Commission Decision of 23 January 2009 amending Decisions 2006/861/EC and 2006/920/EC concerning technical specifications of interoperability relating to subsystems of the trans-European conventional rail system (notified under document number C(2009) 38) (Text with EEA relevance) (2009/107/EC)

amending Decisions 2006/861/EC and 2006/920/EC concerning technical specifications of interoperability relating to subsystems of the trans-European conventional rail system

(2009/107/EC)

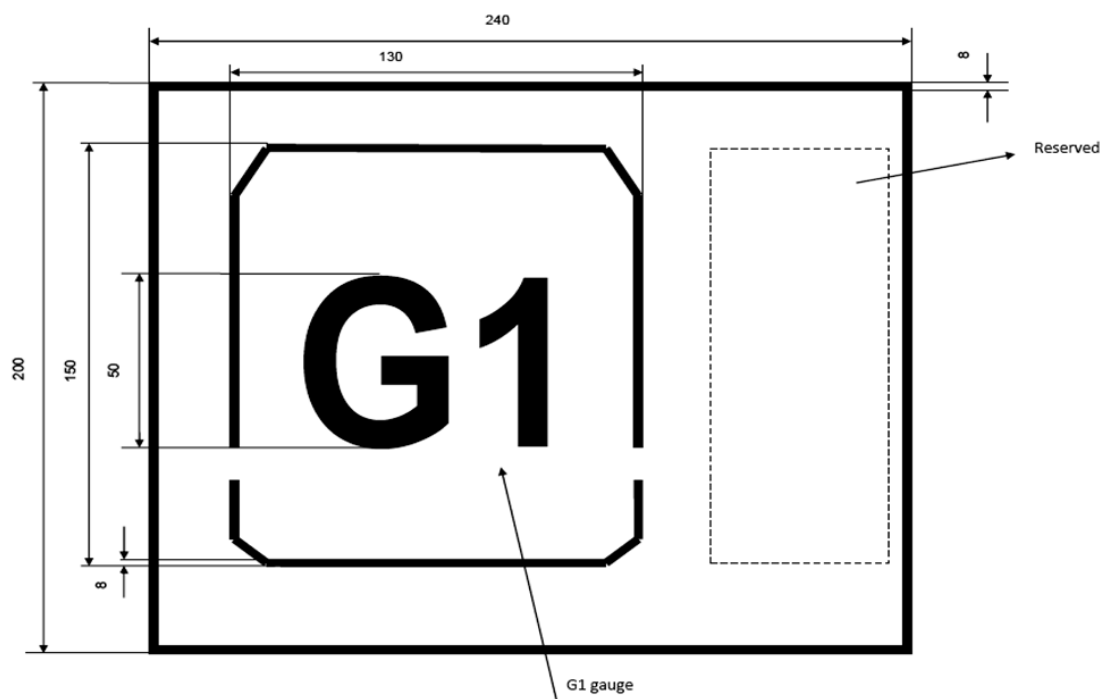
7.6.4. An authorisation of placing in service granted by one Member State shall be valid in all other Member States under the following conditions:

- (a) the wagon has been authorised in accordance with Article 22 of Directive 2008/57/EC, on the basis of this TSI, including the verifications related to the open points identified in Annex JJ part 1;
- (b) the wagon is compatible with the 1435 mm track gauge;
- (c) the wagon has a G1 loading gauge, as specified in Annex C3;
- (d) the wagon is equipped with an axle distance that does not exceed 17 500 mm between two adjacent axles;
- (e) the wagon complies with the requirements of Annex JJ part 2.

B.32. MARKING OF WAGONS GAUGE

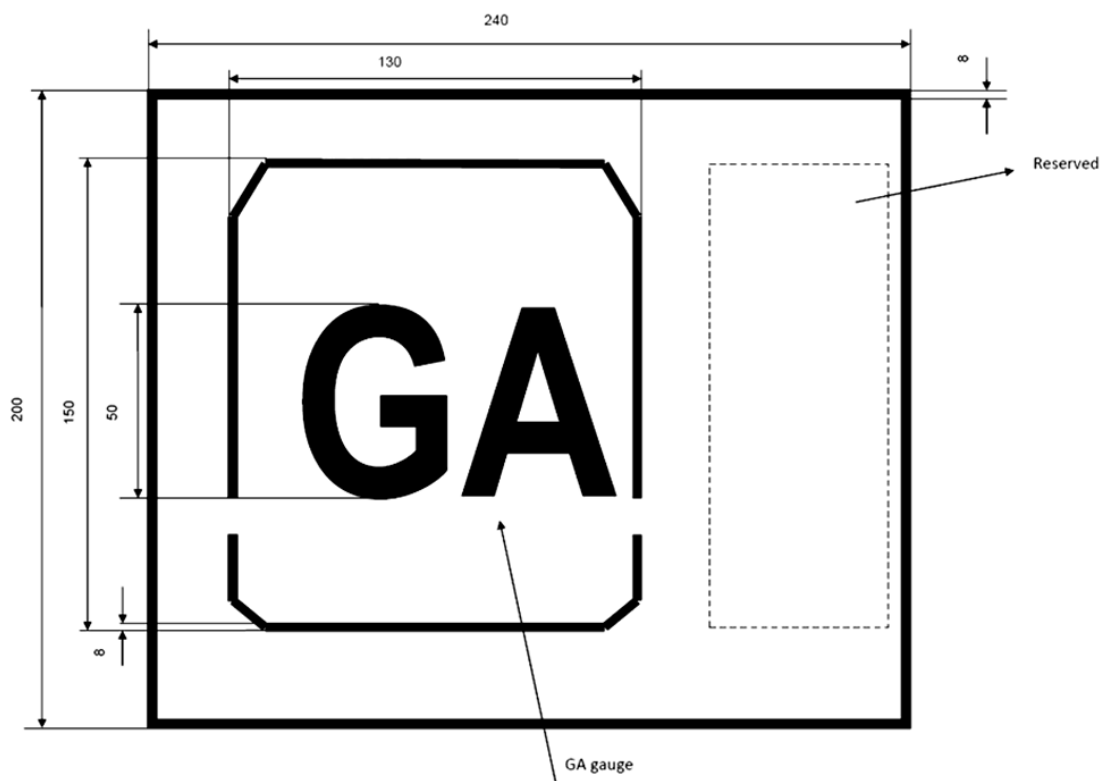
- (a) in point B.3, remark 4) is replaced by the following:
 - 4) Existing wagons that can be forwarded with the same loads as in S-traffic at 120 km/h, are already marked with the sign “***” placed to the right of the maximum load markings; no additional wagons can be added to this category.
- (b) in point B.3, the following remark is added:
 - 5) New wagons with the braking performance of “S2”-wagons according to the table in section 4.2.4.1.2.2, that can be forwarded with the same loads as in S-traffic at 120 km/h according to particular specifications listed in Annex Y, shall have the sign “****” placed to the right of the maximum load markings.
- (c) point B.32 is replaced by the following:

- (1) Wagons built to gauge G1 will be marked as follows:

(2) Wagons built to gauges GA, GB or GC will be marked as follows:

Figure Relevage sur la voie / Rerailing

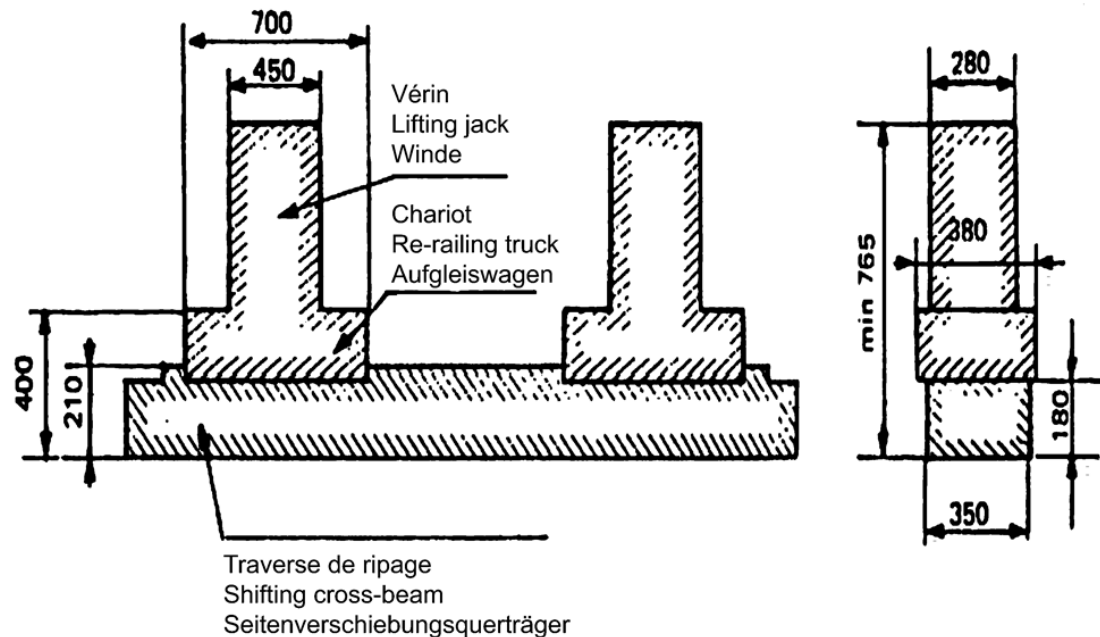
In addition to the specifications of section 4.2.2.3.2.4 of this TSI, the compliance of the jacking with the following diagram is also required:

Figure 1

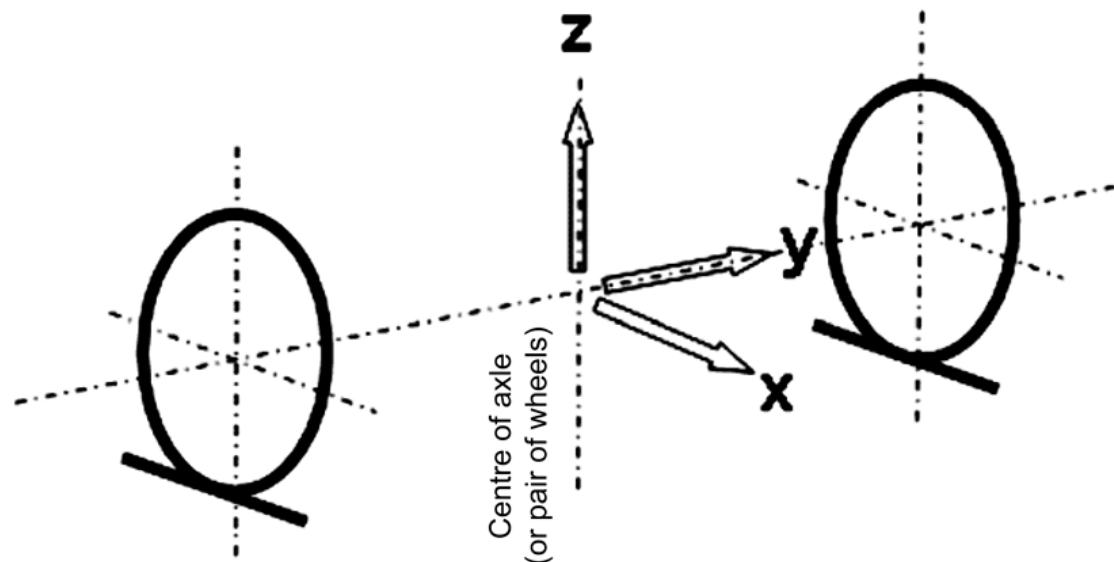
Rolling stock coordinates: rolling stock coordinates, figure 1, are based on the right hand rule Cartesian coordinate system, where the positive X-axis (longitudinal) is along the vehicle in the direction of travel, the Z-axis is vertically upwards and the origin is at the centre of the wheelset axle. The Y-axis is the lateral axis.

Figure 2

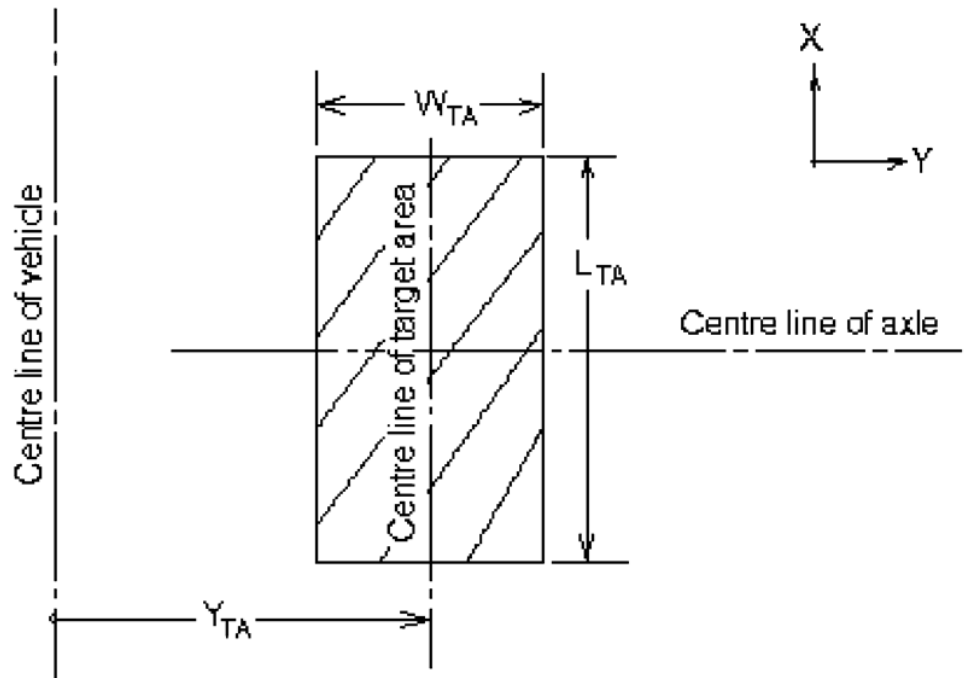
The target area is set in space relative to the axle dimensions, and defines an area in which a HABD can focus to monitor the temperature of an axle box. Figure 2 shows the position and minimum dimensions of the target area using rolling stock coordinates.

- have a lateral width, W_{TA} , greater than or equal to 50 mm;
- have a longitudinal length, L_{TA} , greater than or equal to 100 mm.

In the XY plane the centre of the target area shall be positioned at a lateral distance, Y_{TA} , relative to the centre of the axle (or centre of a pair of wheels at the same position), where 1 065 mm is less than or equal to Y_{TA} and Y_{TA} is less than or equal to 1 095 mm. In the longitudinal axis the centre of the target area shall be congruent with the centre line of the axle.

Figure 3

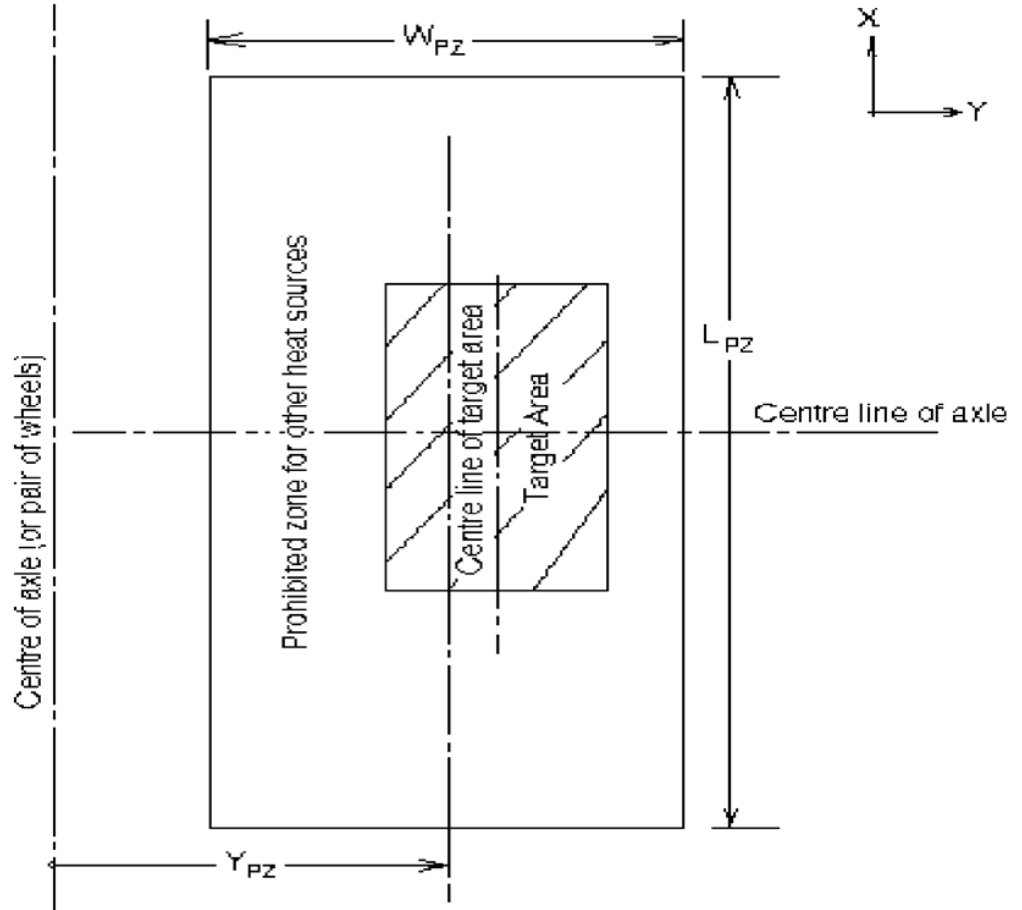
The prohibited zone is defined by a rectangular area, which includes the target area, and is extended vertically to form a virtual cuboid. The dimensions of the cuboid are LPZ and WPZ in the XY plane and HPZ in the vertical axes. Figure 3 shows a possible position of the target area in the prohibitive zone using rolling stock coordinates.

- lateral width, WPZ, greater than or equal to 100 mm;
- longitudinal length, LPZ, greater than or equal to 500 mm;
- vertical height, HPZ, starts at a point in the XY plane immediately above the HABD and ends at either the height of the target area, the height of a thermal shield or the height of the vehicle.

- in the lateral direction, YPZ = 1080 mm ± 5 mm measured relative to the centre of the axle (or centre of a pair of wheels at the same position);
- in the longitudinal direction it shall be congruent with the centre line of the axle ± 5 mm.

ALPHABETICAL MARKING OF THE INTEROPERABILITY CAPABILITY

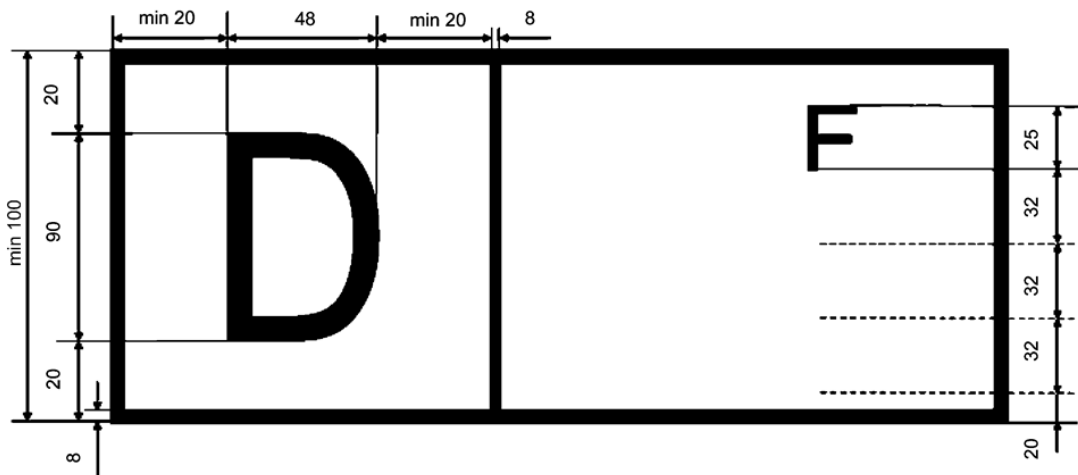
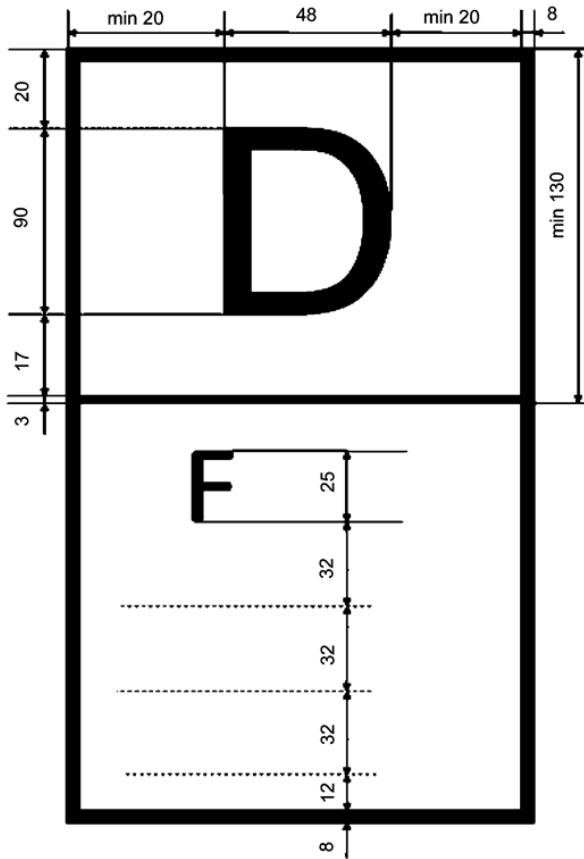
Annex P.5 of Decision 2006/920/EC is replaced by the following:

- “TEN” : Vehicle which complies with the following conditions:
- it complies with all relevant TSIs which are in force at the moment of placing in service and has been authorised to be placed in service according to Article 22(1) of Directive 2008/57/EC,
 - it is provided with an authorisation valid in all Member States in accordance with Article 23(1) of Directive 2008/57/EC, or, as an alternative, it has received individual authorisations by all Member States,
- “PPV/PPW” : Wagon which complies with PPV/PPW agreement (inside OSJD States) (original: ППВ (Правила пользования вагонами в международном сообщении)).
